Impacts of climate variability on wetland salinization in the North American Prairies.

Reply to reviewer #1.

Figure 1: Conceptual diagram of water flow paths (arrows) for extremely rainy summers (A) and snowy winters (B). Oval shapes represent the accumulated salts at the uplands soil.

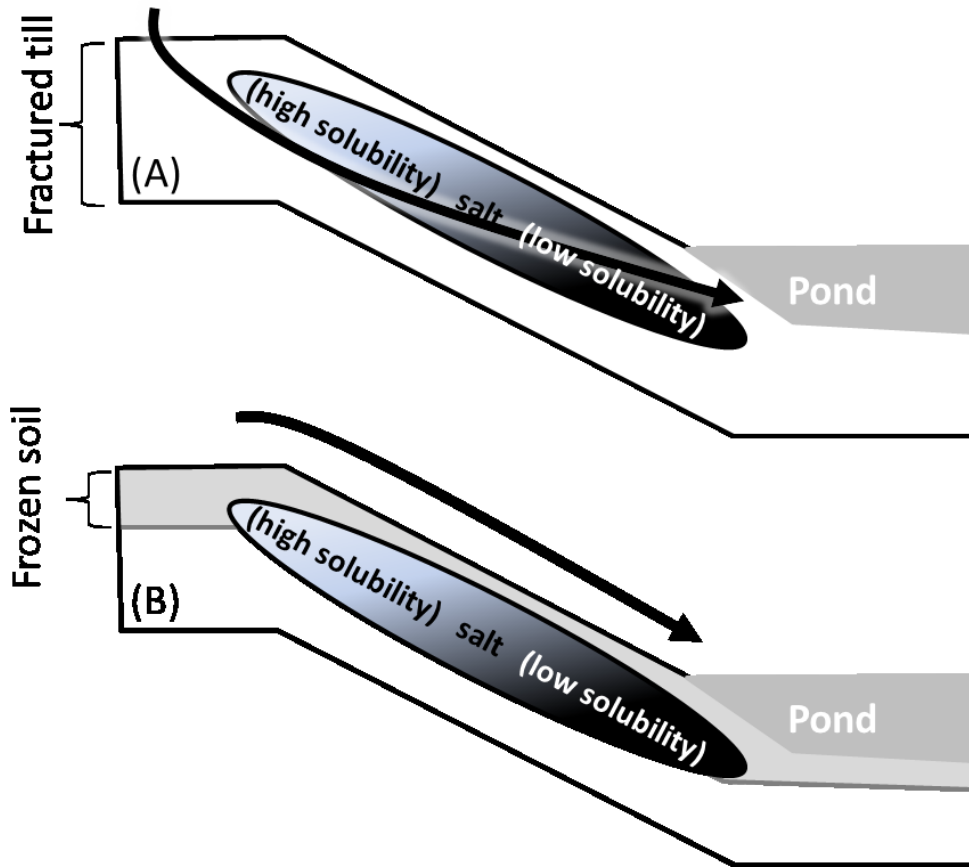
We are grateful to Anonymous Referee #1 for his positive and constructive review. The reviewer's summary of lateral flow/transport processes in frozen and unfrozen conditions is correct. We think the reviewer's idea of adding a conceptual diagram to show the different water flow paths for extreme snowy and rainy conditions is a good idea and the revised paper will include a short section that discusses the different water flow paths together with a conceptual diagram (attached below). In the added section we clearly explain our hypothesis about how snowmelt over frozen soils has only a small impact on salt flushing from the soils into the ponds. In addition, based upon the field measurements reported in the manuscript we will suggest that changes in salinity on seasonal and inter-annual timescales take place due to pathways from the uplands to the ponds, through the shallow subsurface (0-10 m) and not through the deeper aquifers (>15 m) (though these may influence salinity changes on longer time scales, i.e. decades to millennia). We expect this lateral subsurface flow to be dominated by saturated flow, when the shallow water table is within the "effective transmission zone" (i.e. the permeable, weathered near surface), which may persist for very short periods (on the order of days) following intense rain events (as we observed). We will emphasize that future studies need to examine this point more carefully.
